Service Bulletin

No. 010

Model: TX-NR1000, DTR-10.5

Subject: Composite, S-Video picture is too bright.

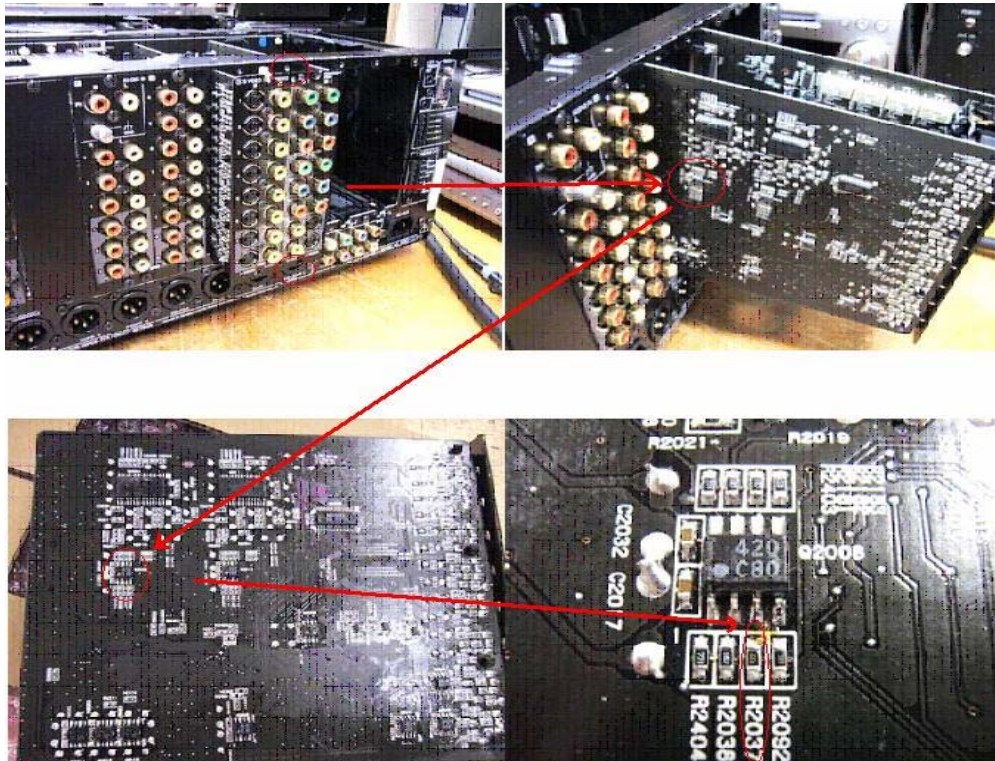
Symptom: The customer complains: When viewing a video source through the set the picture is too bright and washed out.

Solution: Replace resistor R2037, located on the NCVD-8201(C) plug in video board, with an 8.2K ohm resistor. **Note:** the resistor change only applies to the NCVD-8201(C) version video board. The NCVD-8201(B) board already has the correct value resistor.

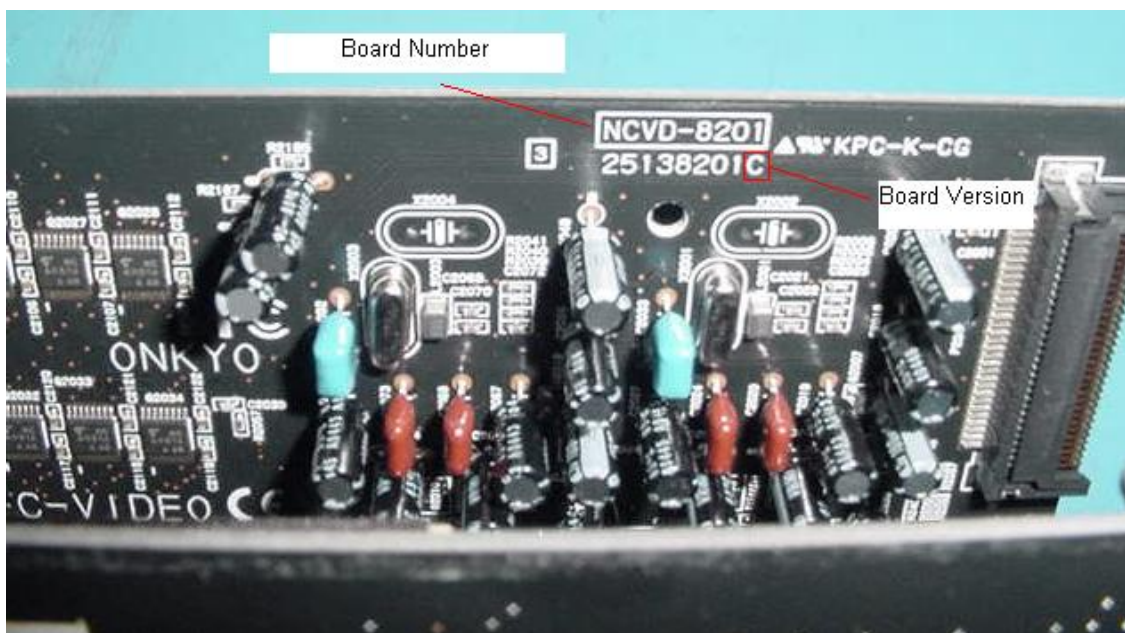
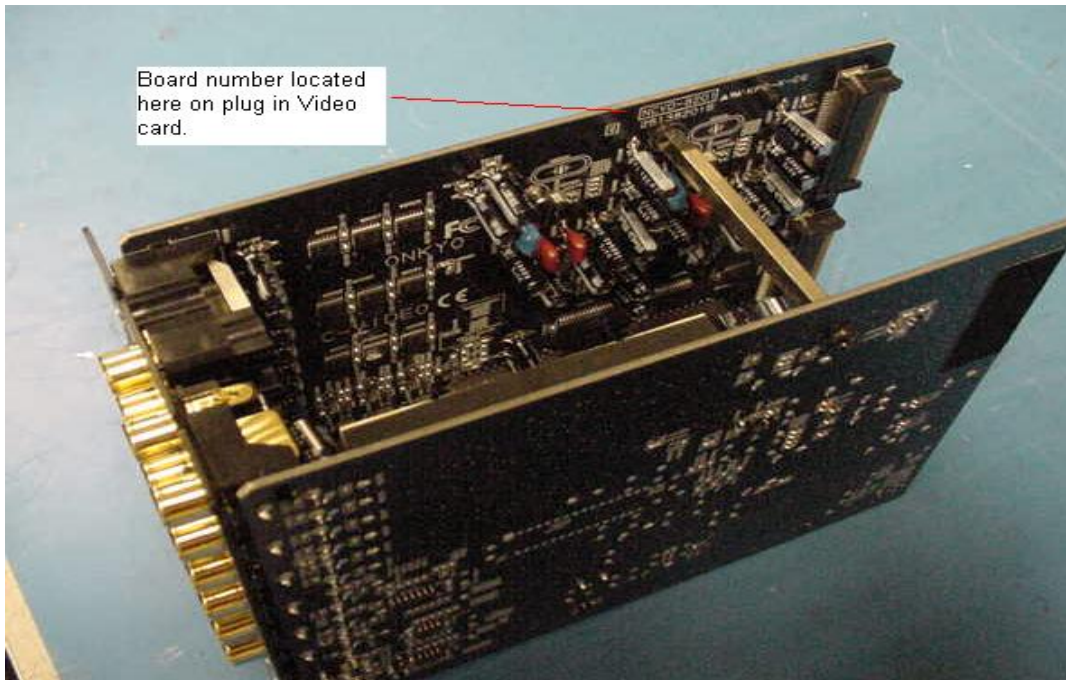
Board Identification: This update only applies to units having the plug in Video Board labeled NCVD-8201 (C). See photos to learn how to identify the video board type.
